WORK ALLOCATION SHEET

Clarendon Ph3a

Drainage Layout Sheet 1 of 3

W257-PTA-DE-ZZ-DR-C-01-8101

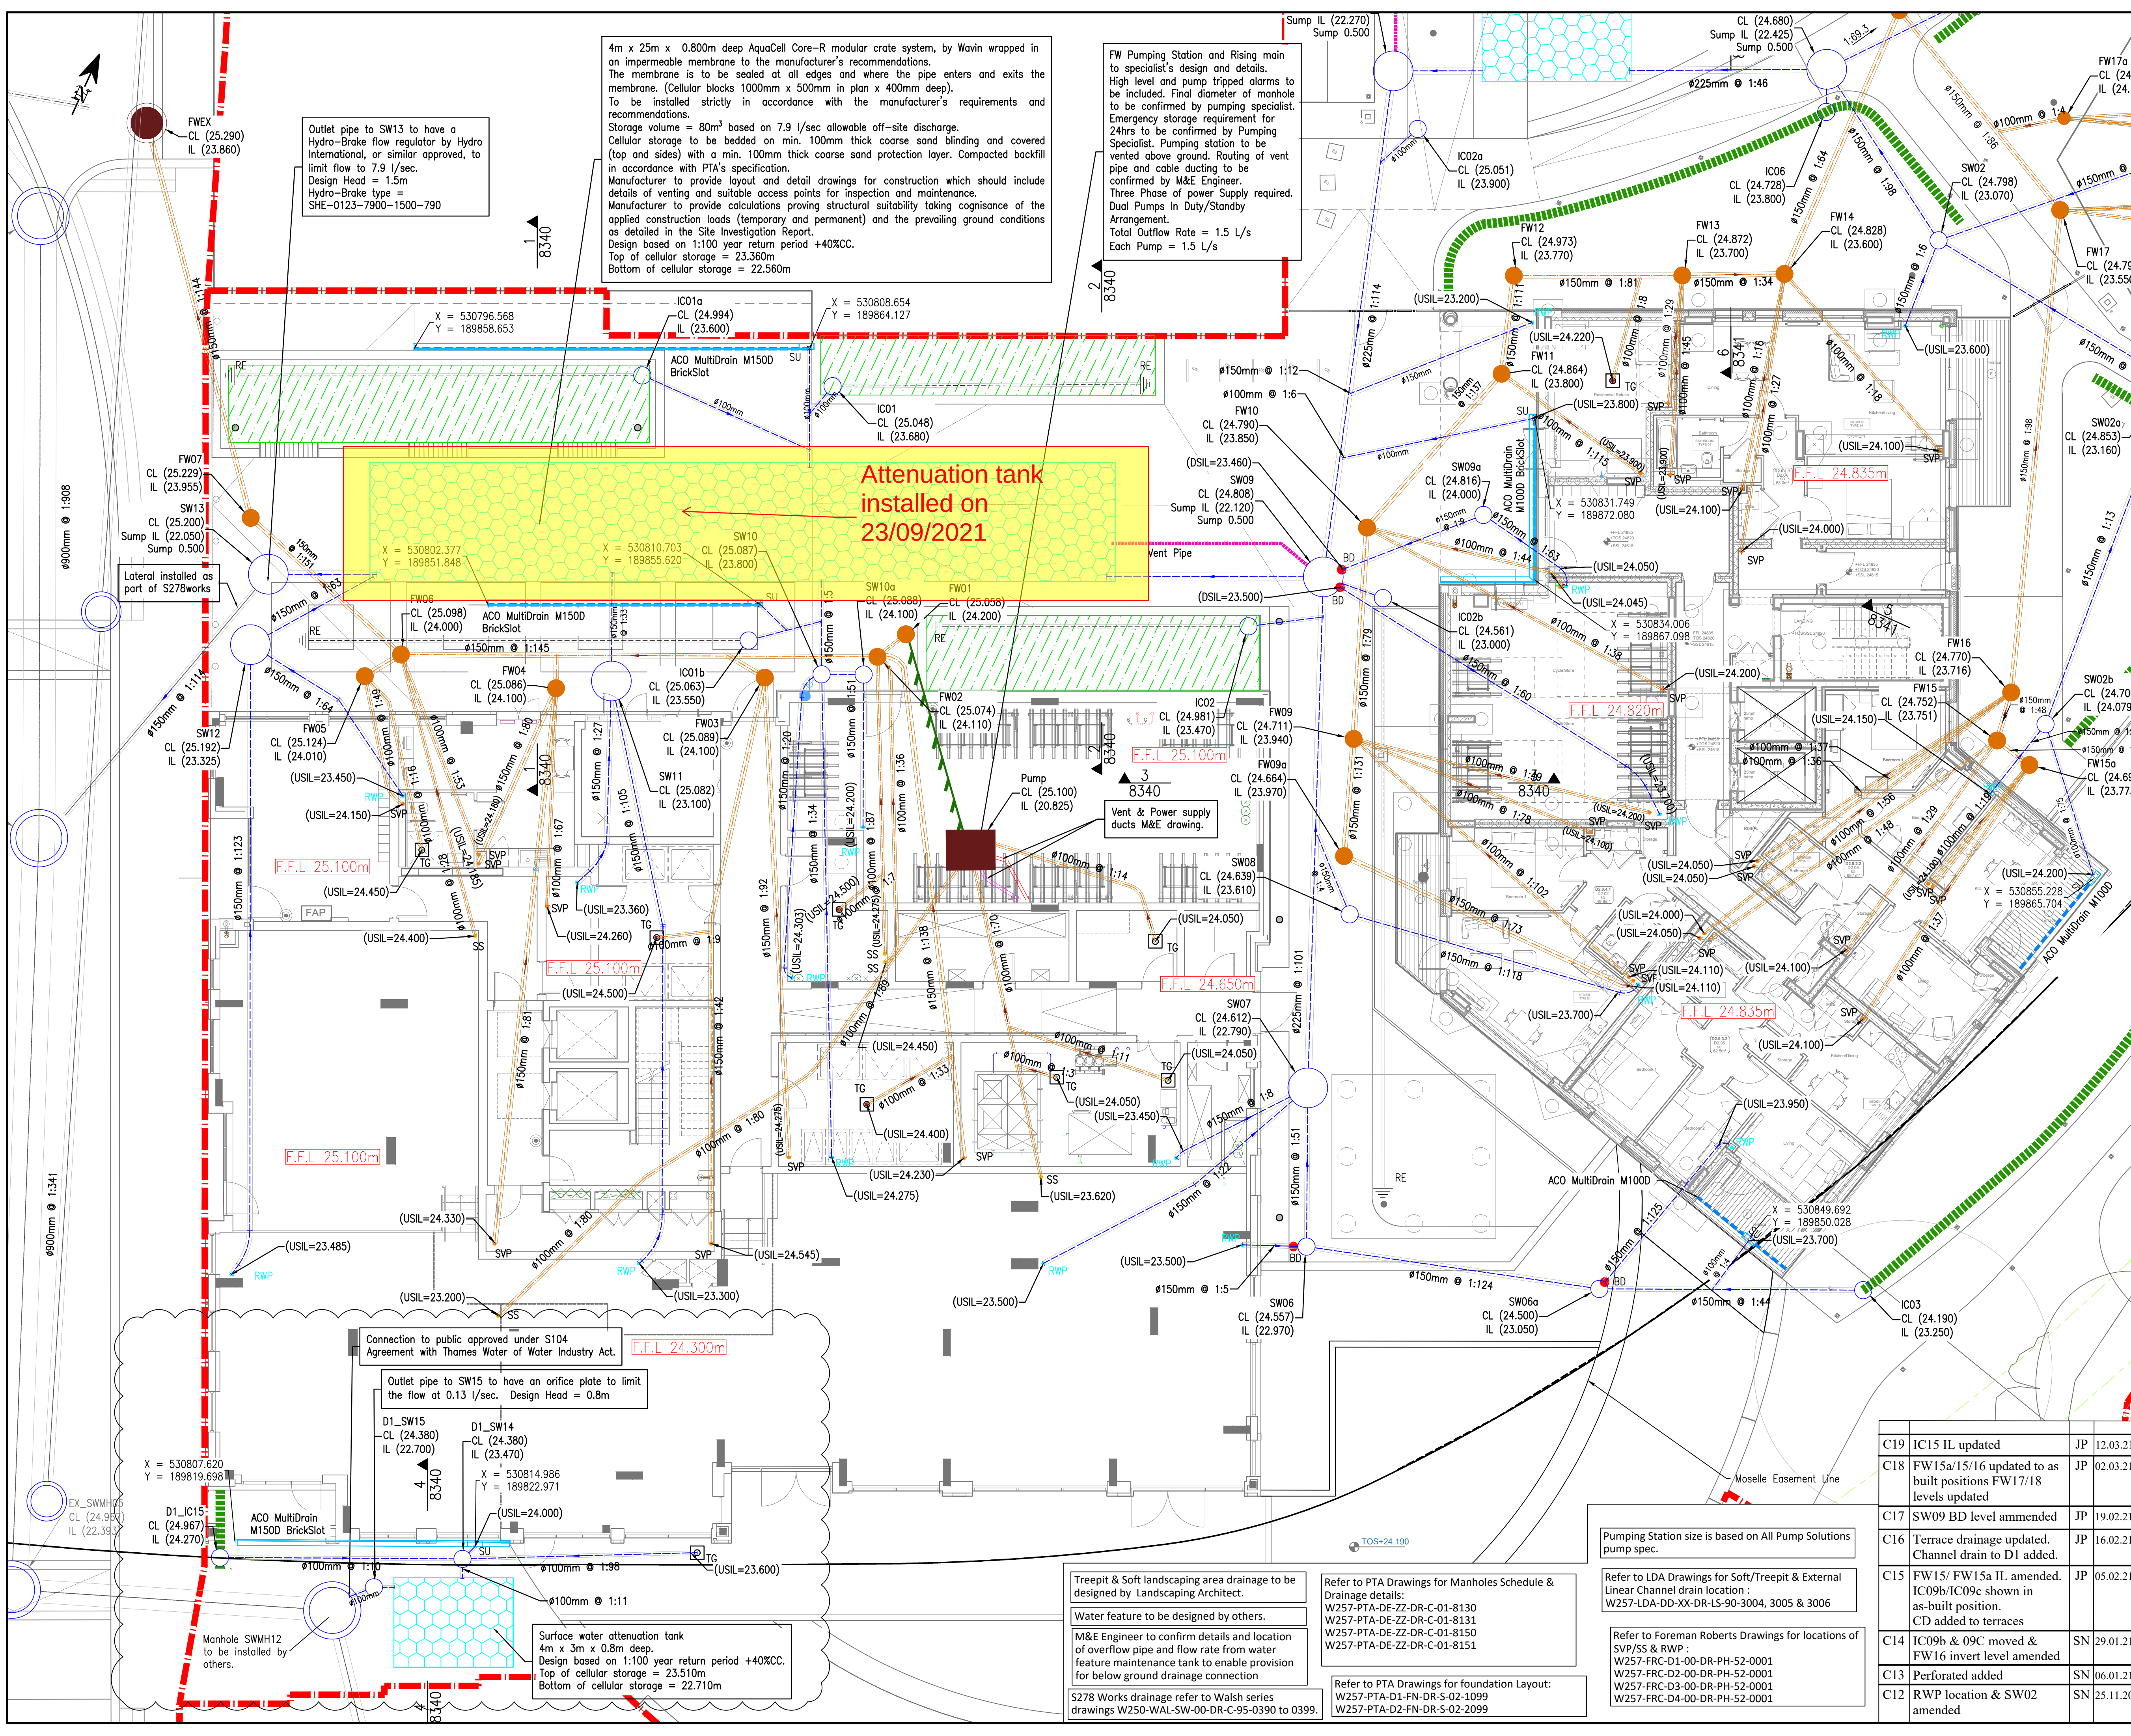
SWMH12 near D1 attenuation tank

IL 22.326

IL 22.666

IL 22.361

Client Contractor: <u>GCL</u>		Location: <u>Wood Green</u>	
Project: <u>Attenuation tank</u>		Date: <u>23.9.21</u>	
Type of work undertaken			
Days Work	Repairs	Other	
<u>Work Achieved</u> <u>25m x 4m x 0.8m</u> ^{tank 1} & flanges, 3@15m, 3@100m, 2@225m <u>4m x 3m x 0.8m</u> ^{tank 2} 22.9.21 - 4 x installers 23.9.21 - 2 x installers, 1 roll Geo Integrity welding test with pool shear test today hours 7:30 - 13:30			
M ² Laid =			
Top - Hats =			
<u>Waiting Time - Reason</u>		<u>Stock Left On Site</u>	
Completed by: Signature: <u>[Signature]</u> Print: <u>James Peter</u>		Client: Signature: <u>[Signature]</u> Print: <u>Koballah De Saiz</u> Position: <u>Eng. rel.</u>
